TITLE:  
ITEM NO:  
DESC.: PLAN, ELEVATIONS, DETAIL  
DESC.: CAFE PANTRY 3392

By: PD Scale: As Noted Job No. Dwg. No.  
Status: IN SUBMITTAL REVIEW Date: 2019-07-08 **02-01**

TITLE:	SECTIONS	Job No.	Dwg. No.
ITEM NO.:	CAFE PANTRY 3392	Scale: As Noted	02-04
DESC.:		Status: IN SUBMITTAL REVIEW	Date: 2019-07-08

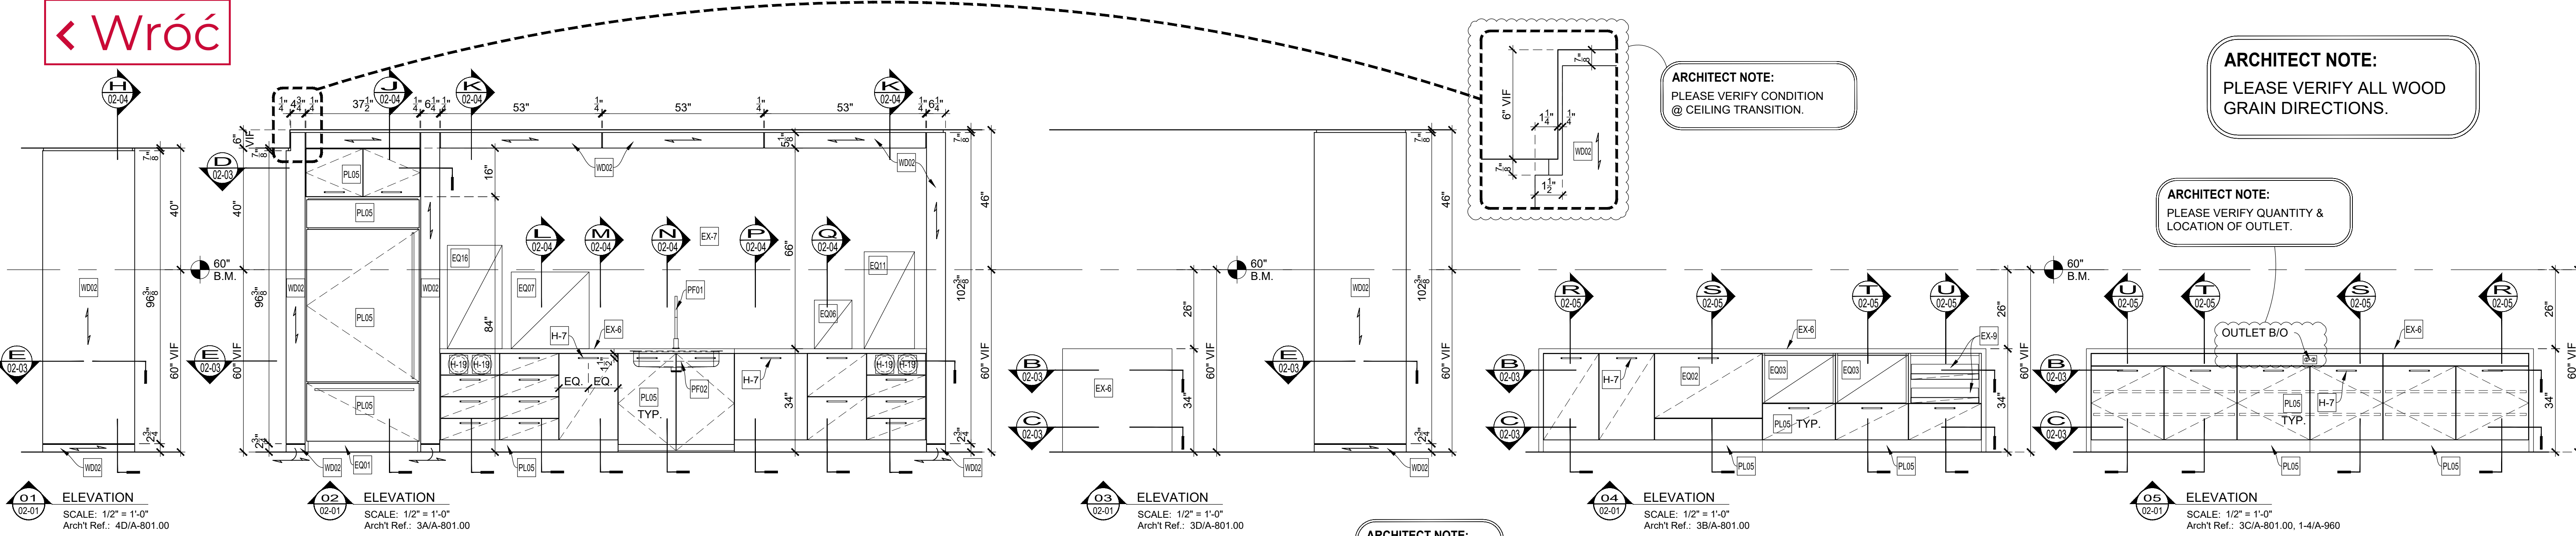
**ARCHITECT NOTE:**  
PLEASE VERIFY CONDITION @ CEILING TRANSITION.

**ARCHITECT NOTE:**  
PLEASE VERIFY ALL WOOD GRAIN DIRECTIONS.

**ARCHITECT NOTE:**  
PLEASE VERIFY QUANTITY & LOCATION OF OUTLET.

**ARCHITECT NOTE:**  
PLEASE VERIFY LOCATION OF PULLS.

**ARCHITECT NOTE:**  
PLEASE PROVIDE APPROVED EQUIPMENT LIST

**PLAN**  
SCALE: 1/2" = 1'-0"  
Arch'l Ref.: 2A/A-801.00

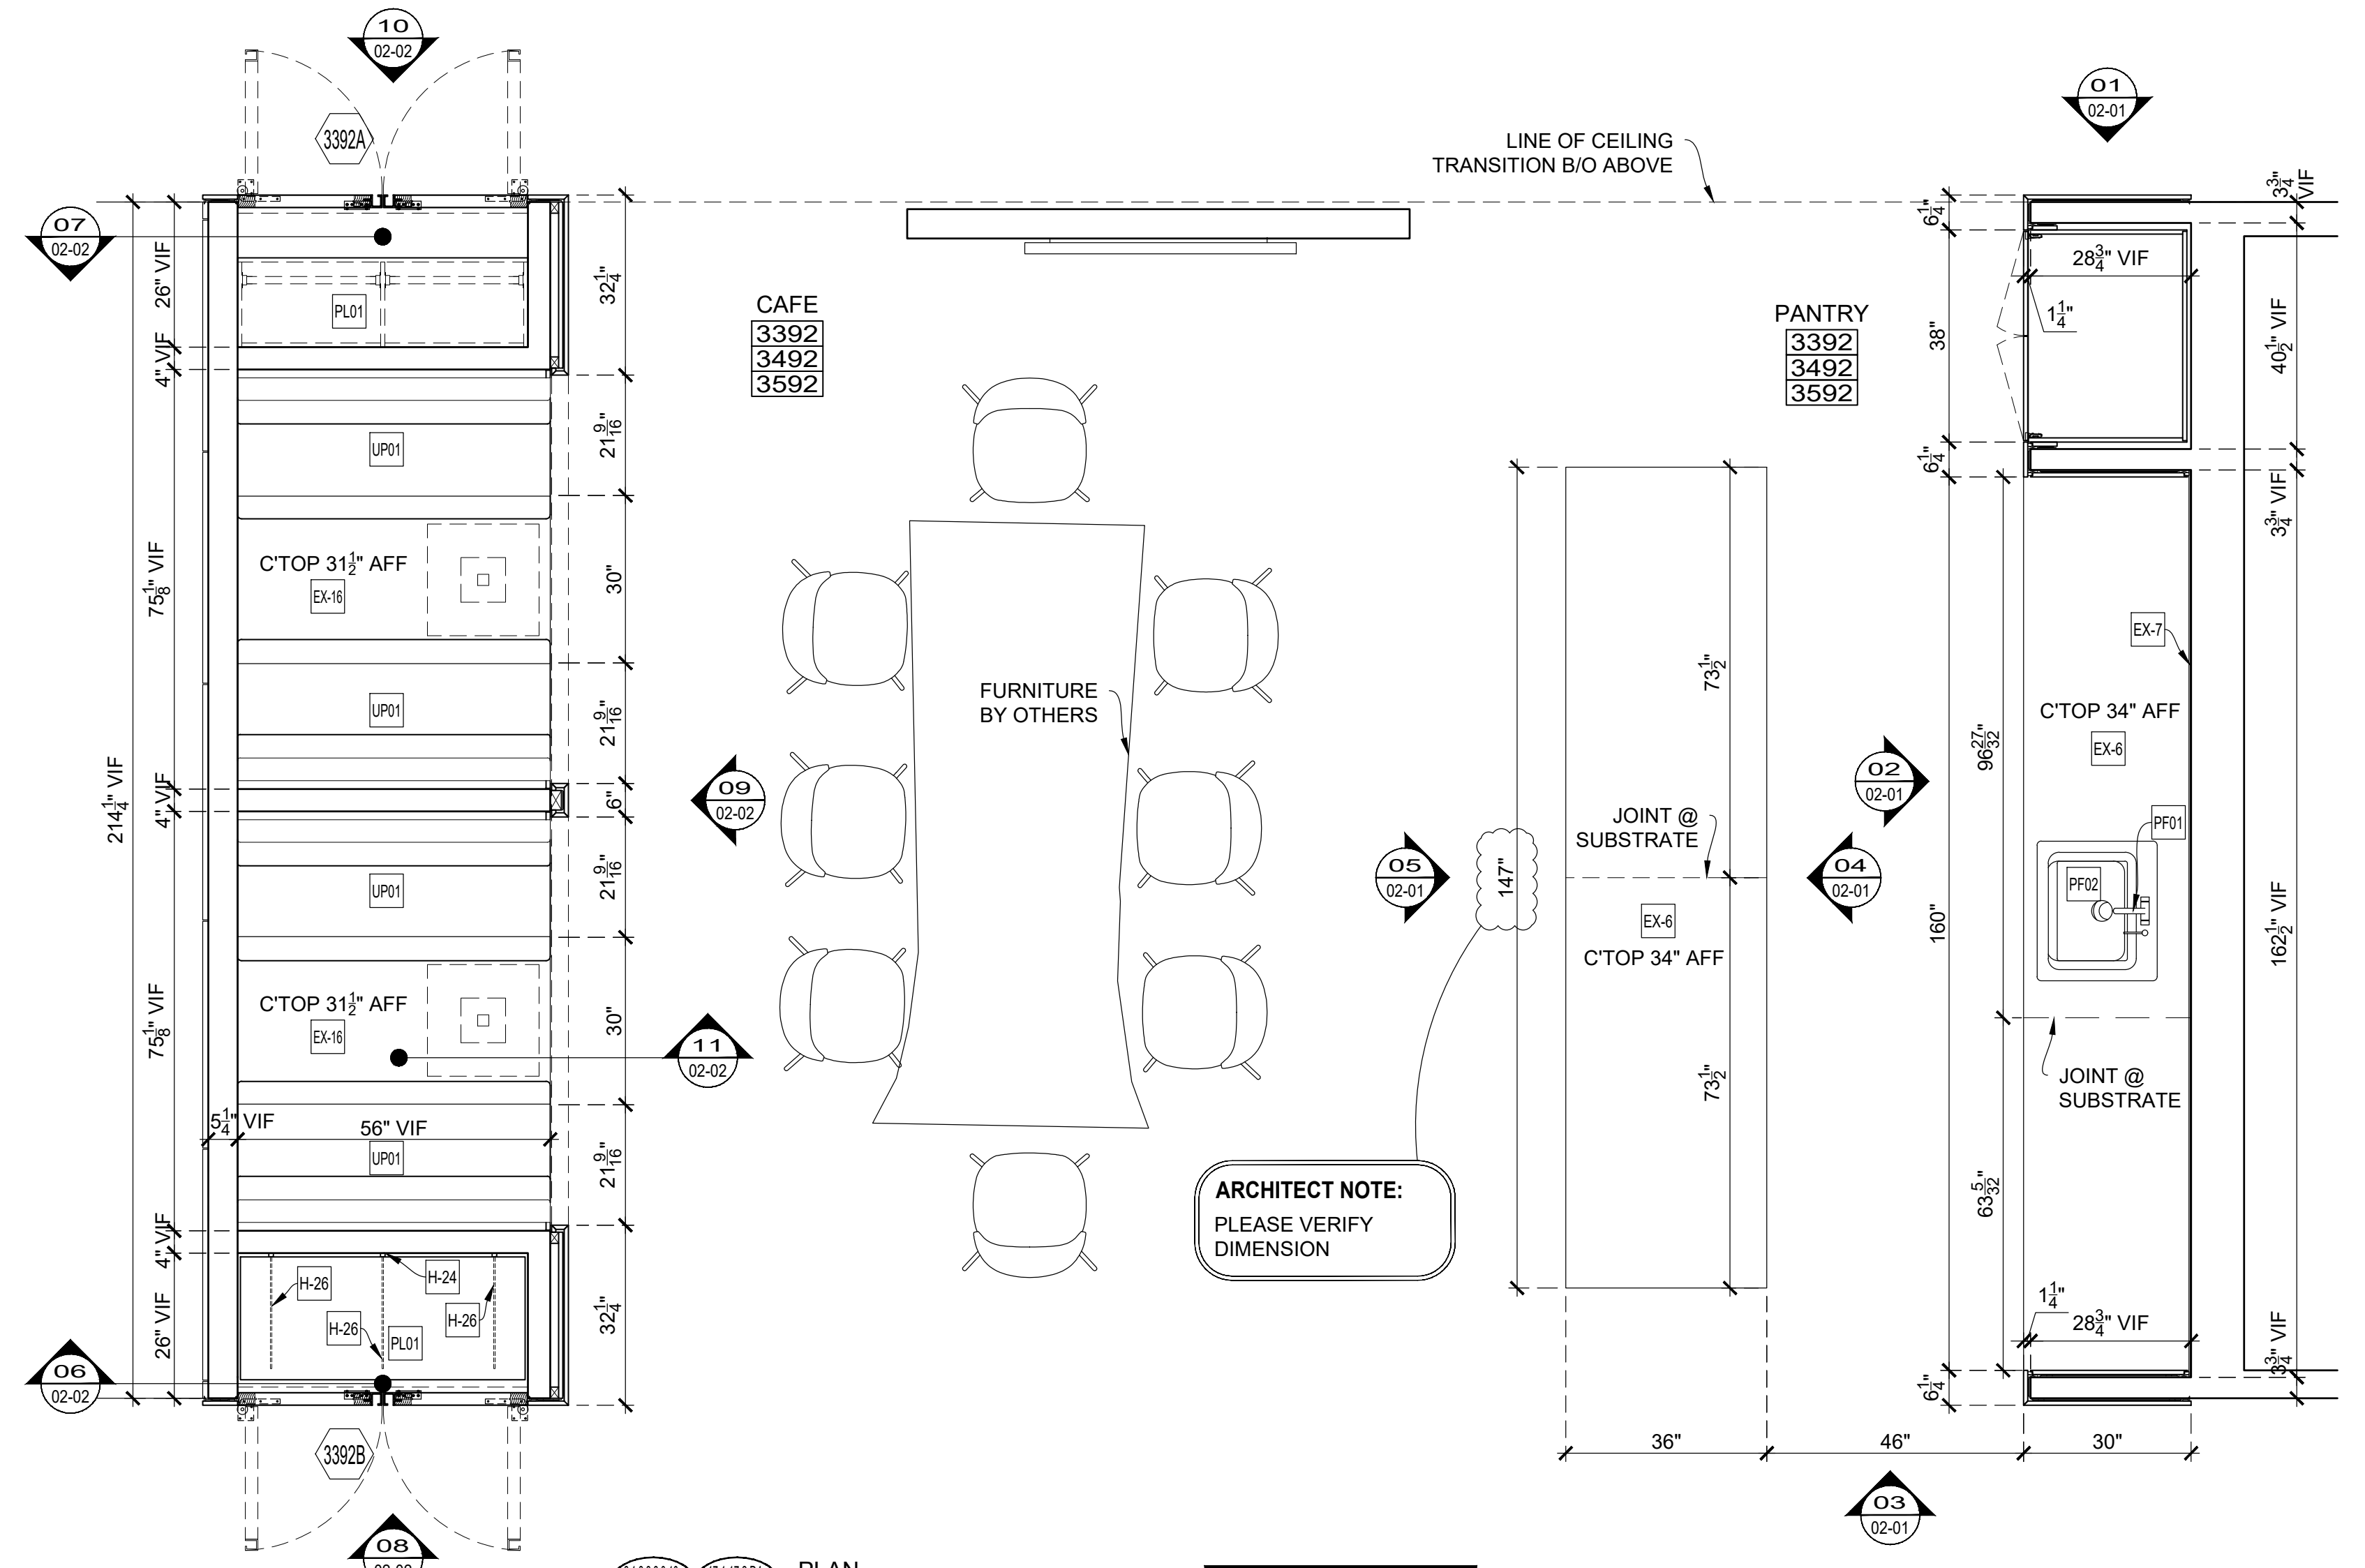
**ARCHITECT/IC NOTE:**  
PLEASE PROVIDE ALL DIMENSIONS FOR COORDINATION.

**ELEVATION 10**  
SCALE: 1/2" = 1'-0"  
Arch't Ref.: 4D/A-801.00

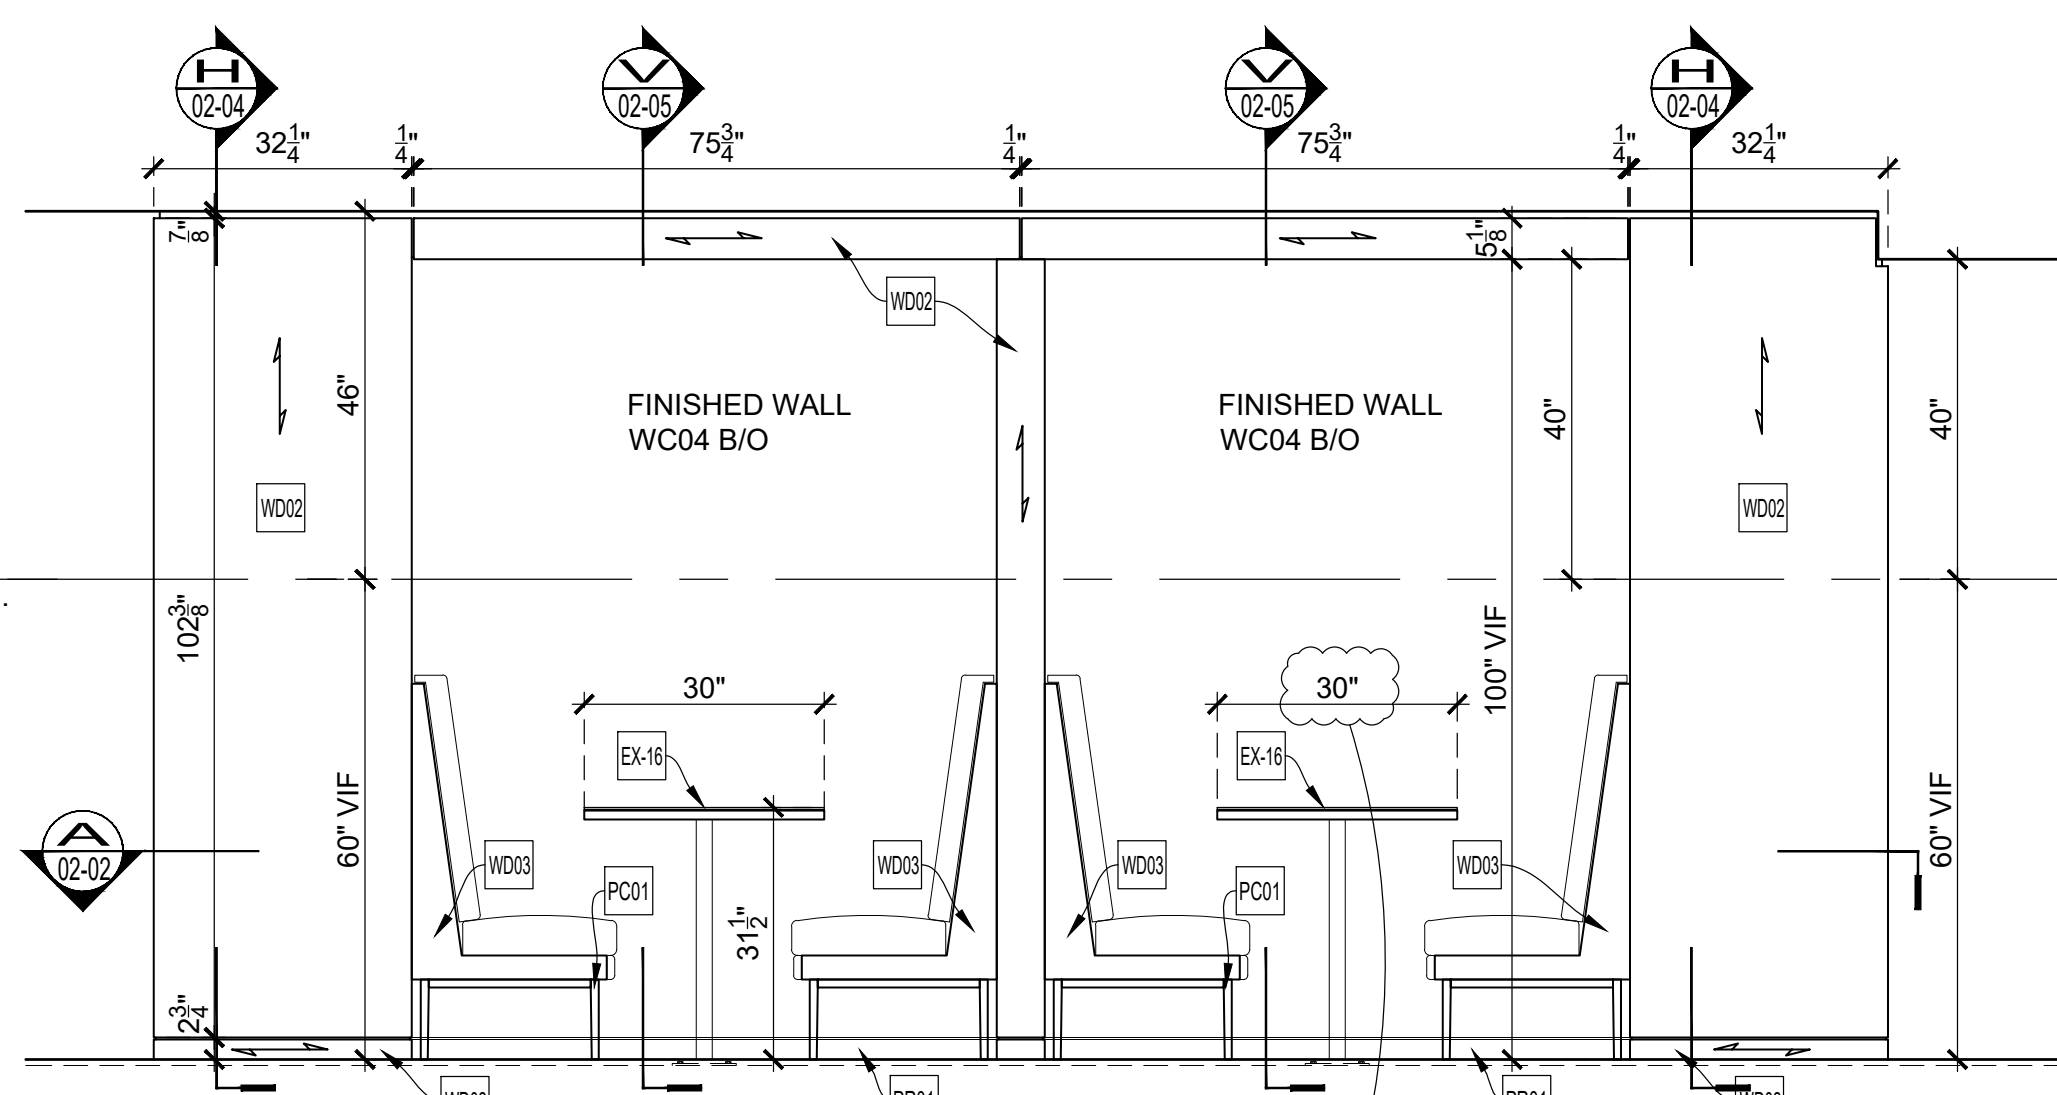
**ARCHITECT NOTE:**  
PLEASE VERIFY DIMENSION

**HARDWARE SCHEDULE**

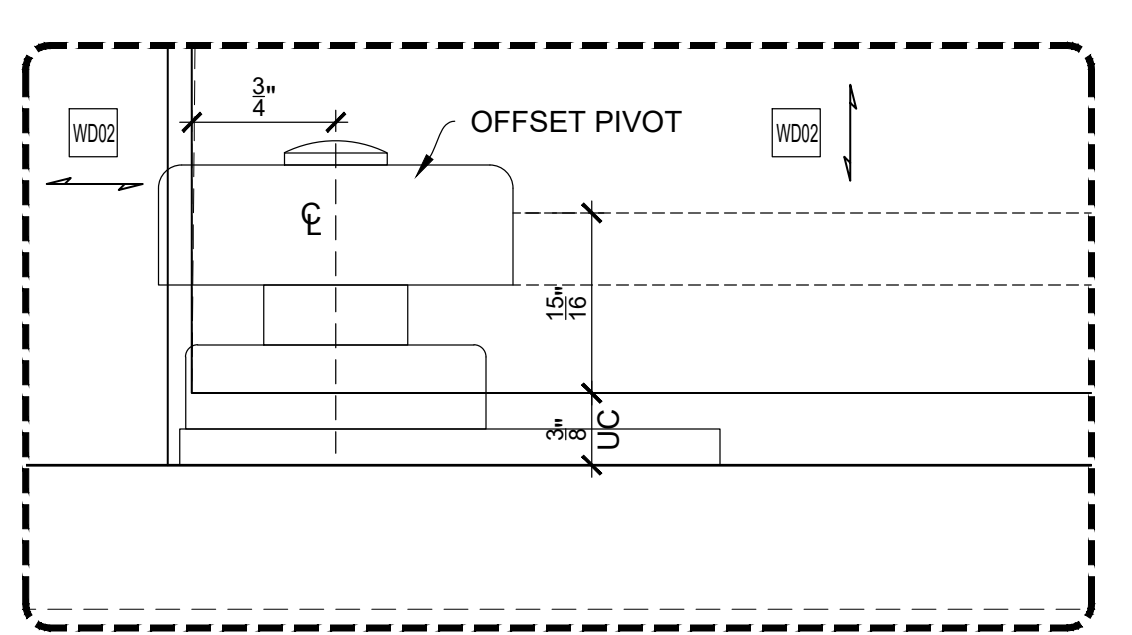
**ARCHITECT NOTE:**  
PLEASE PROVIDE APPROVED HARDWARE LIST FOR COORDINATION

**B PLAN SECTION**  
SCALE: 1-1/2" = 1'-0"  
Arch'l Ref.: NONE

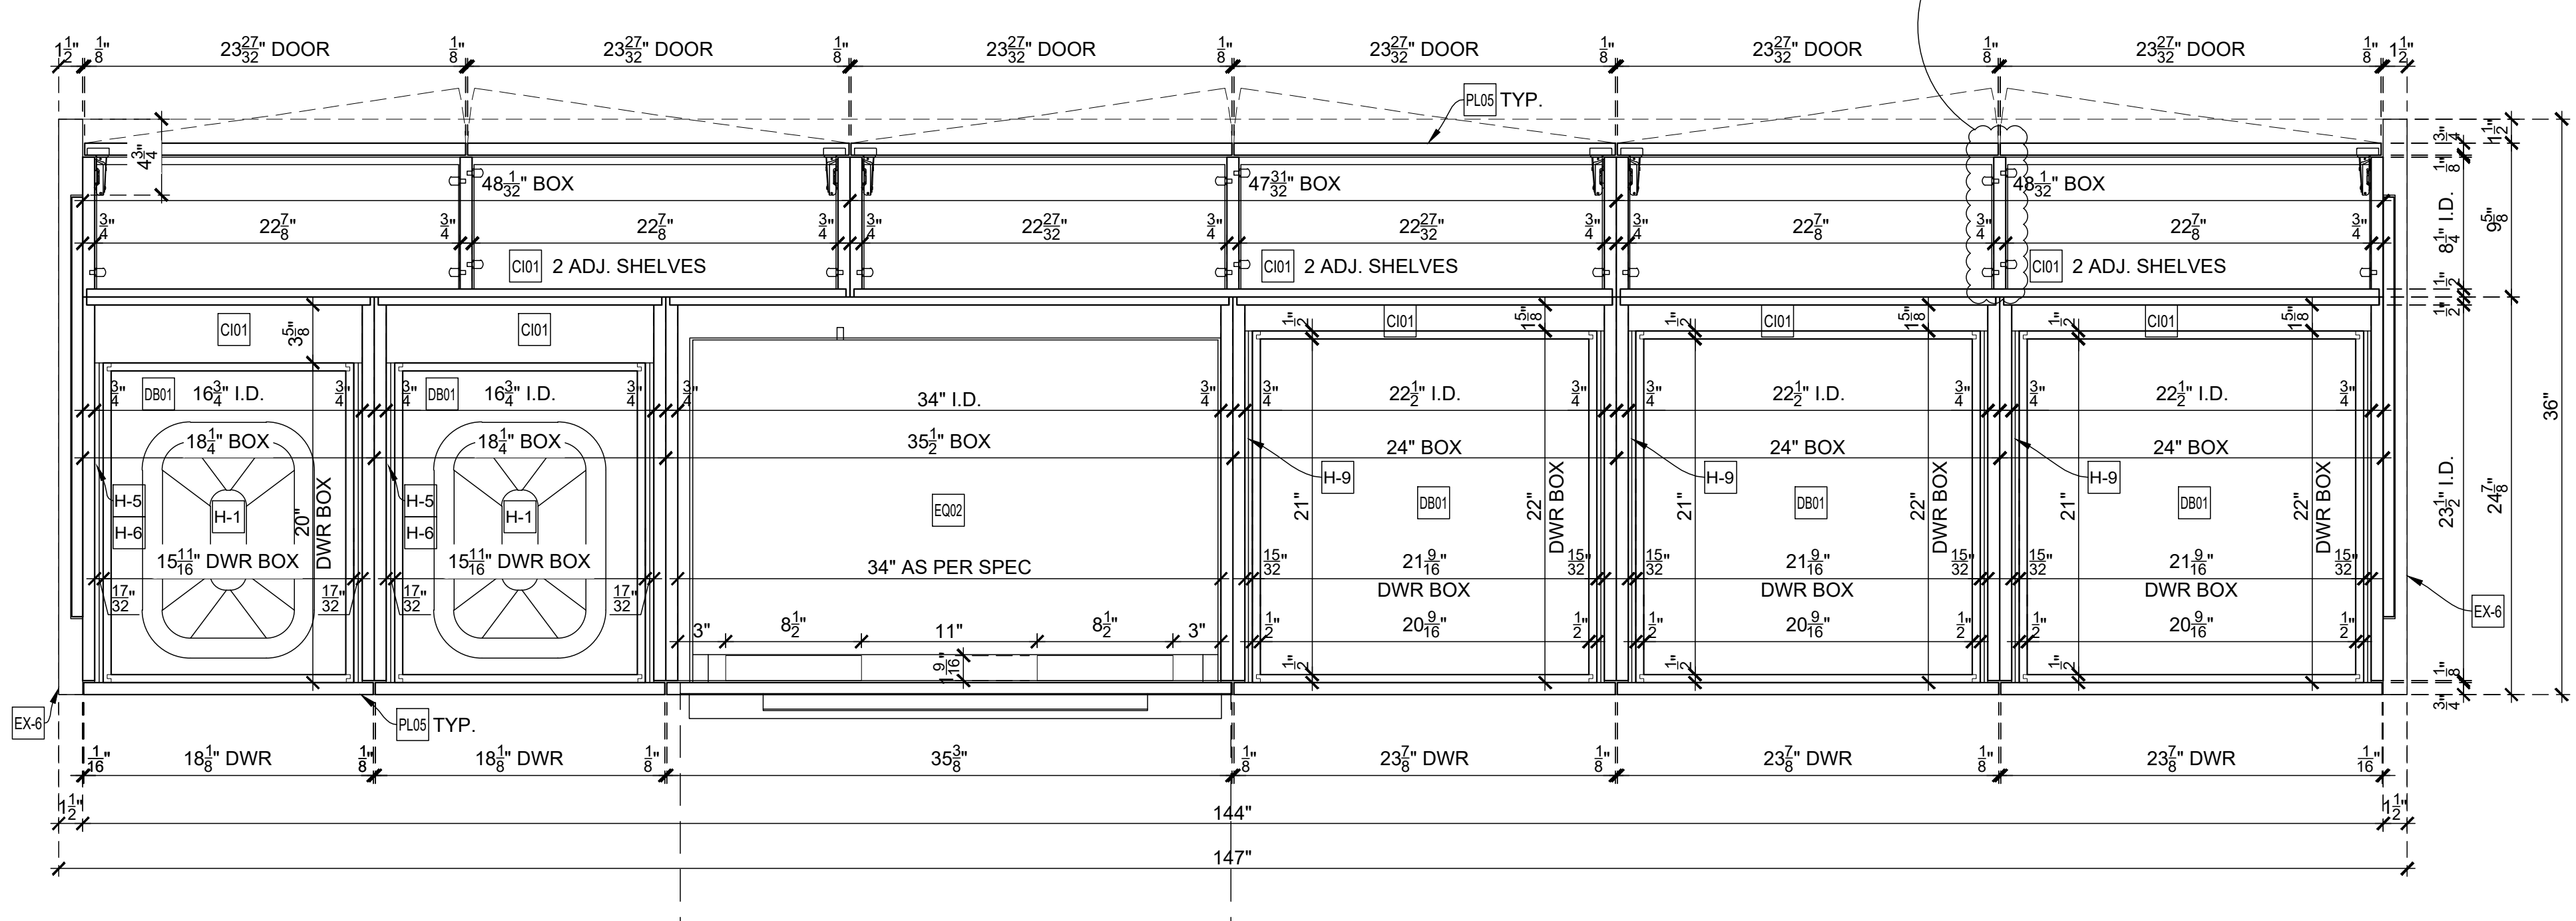
**ARCHITECT NOTE:**  
USE OF DIVIDER IS RECOMMENDED IF INSIDE WIDTH OF CABINET EXCEEDS 36". PLEASE VERIFY CONDITION.
